# Work Order ID 94354

Item Name: Crosstube Turning Detail

DRAWING NO. D412-664-243	TITLE CROSSTUBE ASSEMBLY (412 HI AFT)	REV. E	<b>DART AEROSPACE LTD ENGINEERING ORDER</b>		D.E.O. NO. D412-664-243-E-1	SHEET NO. SHEET 1 OF 2	SCALE NTS
DRAWN	CHECKED	MFG. APPR.	APPROVED	DE APPR.			
DATE 11.03.31	DATE 11/03/31	DATE 11.03.31	DATE 11/03/31	DATE 11-03-31

DRAWING NO. D412-664-243	TITLE CROSSTUBE ASSEMBLY (412 HI AFT)	REV. E	DART AEROSPACE LTD ENGINEERING ORDER		D.E.O. NO. D412-664-243-E-4	SHEET NO. SHEET 1 OF 3	SCALE NTS
DRAWN [Signature]	CHECKED [Signature]	MFG. APPR. [Signature]	APPROVED [Signature]		DE APPR. [Signature]		
DATE 12.08.21	DATE 12.08.30	DATE 12.08.30	DATE 12/8/30		DATE 12.08.30

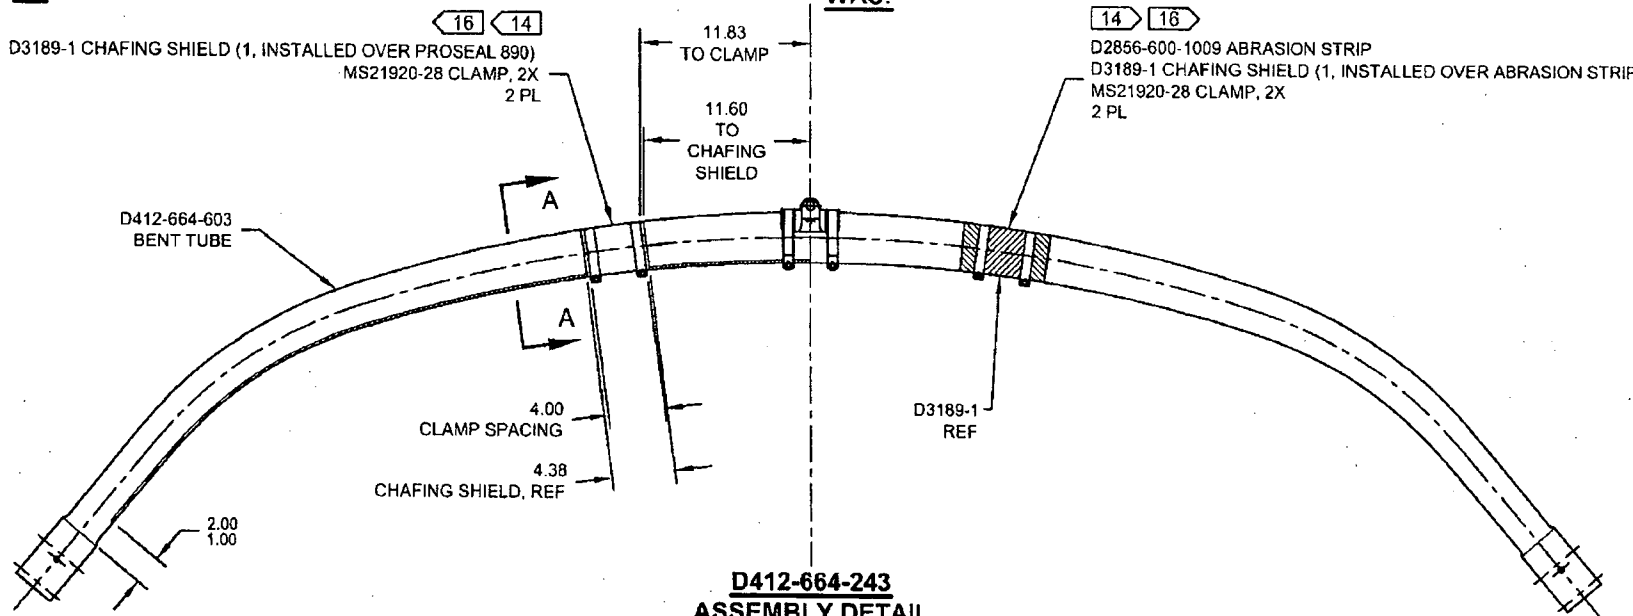
REMOVED ABRASION STRIP IN FAVOR OF A THIN LAYER OF PROSEAL 890. UPDATE INSTALLATION OF CHAFING SHIELDS AND REDUCE TORQUE TO 40-50 IN-LBS. THIS ENGINEERING ORDER SUPERCEDES DEO D412-664-243-E-1.

NOTES 2, 14, AND 16 ON SHEET 1 ARE AMENDED AS FOLLOWS:

- 2) FINISH: CHEMICAL CONVERSION COAT PER DART QSI 005 4.1  
PRIME INSIDE AND OUTSIDE PER DART QSI 005 4.2  
MASK UNDERSIDE OF CROSSTUBE AS SHOWN (HATCHED AREA)  
PAINT OUTSIDE PER DART QSI 005 4.2  
AFTER PAINTING, APPLY CLEAR COAT ON HATCHED AREA
- 14) APPLY A THIN COAT OF PROSEAL 890 ON INSIDE CONCAVE SURFACE OF D3189-1 CHAFING SHIELD AND LET CURE PER MANUFACTURER'S INSTRUCTIONS. INSTALL PROSEALED D3189-1 CHAFING SHIELD ONTO CROSSTUBE BY APPLYING A THIN COAT OF PROSEAL 890 ONTO CROSSTUBE. BE SURE TO ELIMINATE ANY AIR GAPS.
- 16) TORQUE CLAMPS ON D2896-1 SUPPORT 80 TO 100 IN-LB. **TORQUE CLAMPS ON D3189-1 CHAFING SHIELD 40 TO 50 IN-LB.** ENSURE AT LEAST 1.5 THREADS SHOWING IN SAFETY AND THAT NUT HAS NOT BOTTOMED-OUT AFTER TORQUING.

**D412-664-243  
ASSEMBLY DETAIL**

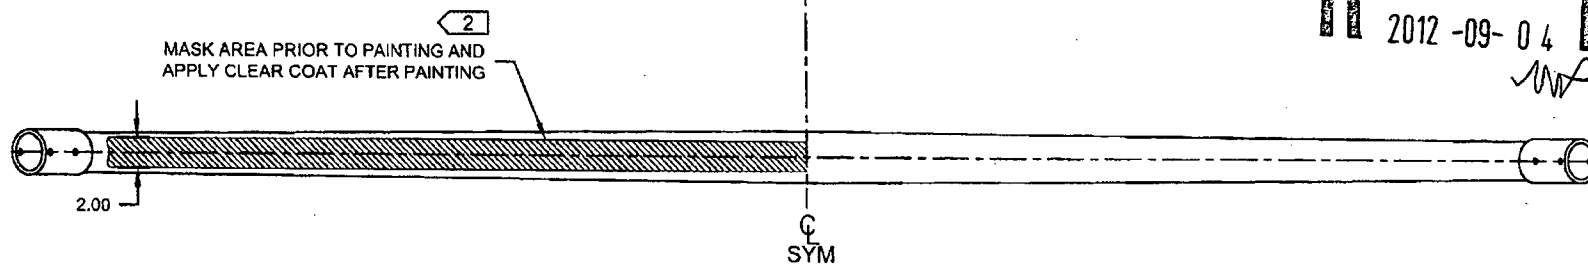
**IS:**

D3189-1 CHAFING SHIELD (1, INSTALLED OVER PROSEAL 890)  
MS21920-28 CLAMP, 2X  
2 PL

**WAS:**

D2856-600-1009 ABRASION STRIP  
D3189-1 CHAFING SHIELD (1, INSTALLED OVER ABRASION STRIP)  
MS21920-28 CLAMP, 2X  
2 PL
